Three Mile Island Nuclear Station, Unit 2 (TMI-2)
 Operating License No. DPR-73
 Docket No. 50-320
 Safety Evaluation Report for
 Core Stratification Sample Acquisition, Revision 3,
 Response to NRC Comments on Safety Evaluation Report for
 Core Stratification Sample Acquisition, Revision 1

Response to NRC Comments on Core Stratification Sample Acquisition SER,
Revision 1

TMI-2 DIVISION SAFETY EVALUATION REPORT FOR

GPU NuclearNO.
15737-2-G07-109Title Safety Evaluation Report for Core Stratification Sample
AcquisitionPAGE OF
2 35

FIGURE 1
LOCATIONS OF LOADS

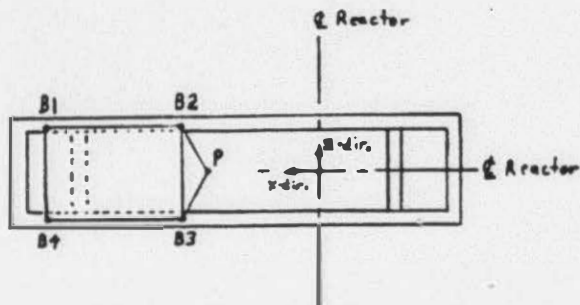
Please provide details of drilling platform and actions including:

- a. Load and load distribution of platform
- b. Location of supports and contact points
- c. Dynamic effect of drilling action
- d. Total weight of drill rig

The Drill Indexing Platform Structure Assembly is comprised of three major subassemblies identified as the wing Assembly (consisting of 4"x4"x1/4" structural tubing), the Upper Level Assembly (consisting of

6"x6"x1/4" structural tubing), and the Lower Level Assembly (consisting of 4"x4"x1/4" and 6"x6"x1/4" structural tubing). Drawing 419932 in Volume II of EGG-TMI-6824, "TMI-2 Core Stratification Sample Project System Design Description Drawings" shows these assemblies. The structure assembly was evaluated for structural integrity using four different load cases with each load case assuming three different indexing positions for a total of twelve load combinations. Table 1 shows the loads in common to the twelve load combinations. This total load is 22,400 pounds. Table 2 shows the additional loads caused by drilling actions as described in the table. Table 3 gives a summary of the twelve load combinations. Figure 1 graphically presents the locations of the applied loads. The maximum primary stresses to the main structural members are shown in Table 4 and are shown to be much less than the AISC allowables.

*NOTE: Weight W3 and W4 have three alternate locations relative to point 'P' as specified by dimension "X." (See Table 3 and Figure 1).

FIGURE 2 SHIELDED WORK PLATFORM

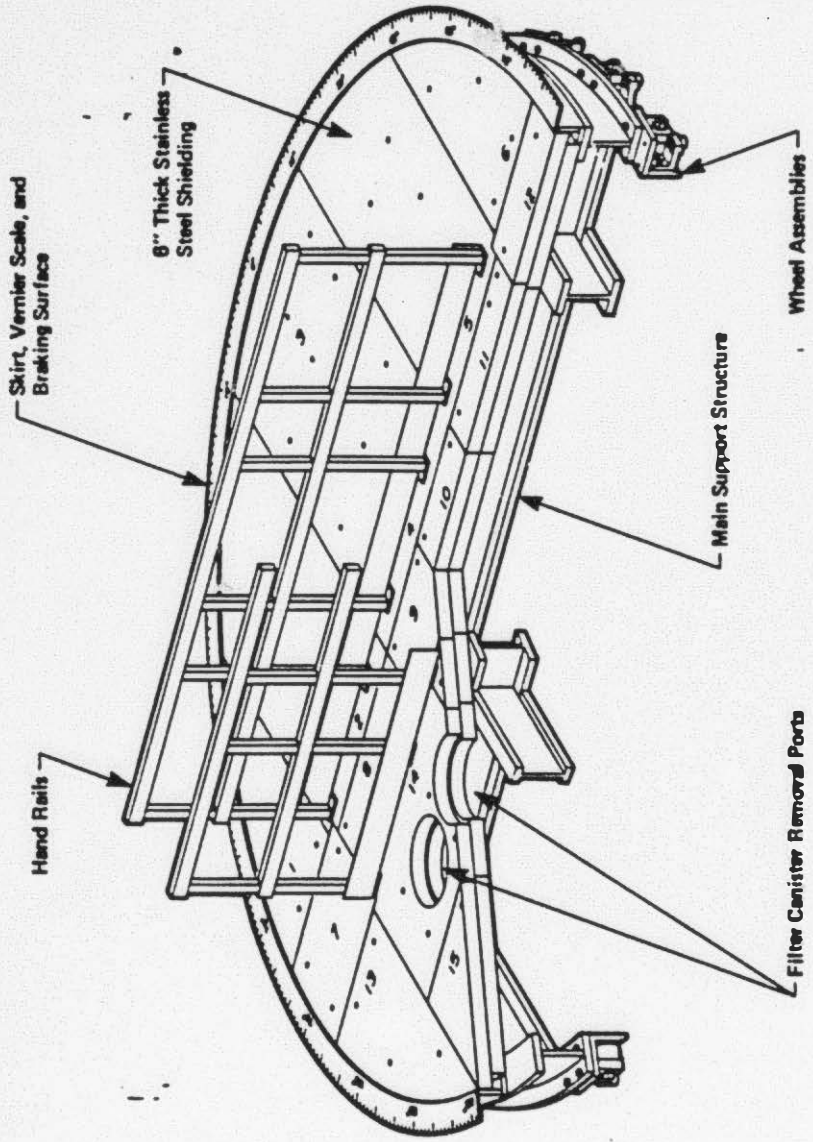
Please provide analyses and calculations to substantiate that:

- a. Existing structure can take the platform load and operating forces;
- b. Reactor vessel can take the operating forces; and
- c. Accidents in operation will not damage the system.

- a. The Defueling Work Platform (DWP) is positioned over the Reactor Vessel and is supported from the refueling canal floor by the Shielded Support Structure (SSS). The DWP consists of a circular beam approximately 17 feet in diameter with interior cross beams as shown in Figure 2. The platform circular and cross beams are welded girders made of 304 stainless steel. The platform is supported by 22 wheel assemblies that ride on a rail mounted on the SSS shown in Figure 3. The SSS consists of frame work made of ASTM A36 carbon steel resting on four columns as shown in Figure 4.

Structural analyses have been performed to evaluate the structural integrity of the DWP and the SSS. The analyses found that the load case shown in Figure 5 with the shield collar at Location 'A' (Denoted as "Case 2") to be the most limiting for the defueling equipment cases. All cases considered the live load of 100 p.s.f. (total of 24,300 lbs.) and the platform shielding weight (total of 81,101 lbs.). Two cases were considered for the core drilling equipment. The core drilling cases considered the total live load and the total platform shielding weight along with the loads denoted as "A", "D", and "E" shown in Figure 5. Each core drilling case also includes the loads shown in Table 1 of the response to Comment 3 applied at the Reactor Vessel centerline. The two core drilling cases differ by the loads imposed on the platform during core drilling operations. Core drilling Case 1 assumes a 14,000 ft-lb moment across the working slot at the Reactor Vessel centerline to evaluate the reaction loads on the bit described as Cases 1 and 2 in Table 2 of the response to Comment 3. Core drilling Case 2 assumes a 10,000 pounds downward force applied at the Reactor Vessel centerline to evaluate the reaction load on the bit described as Case 4 in Table 2 of the response to Comment 3.
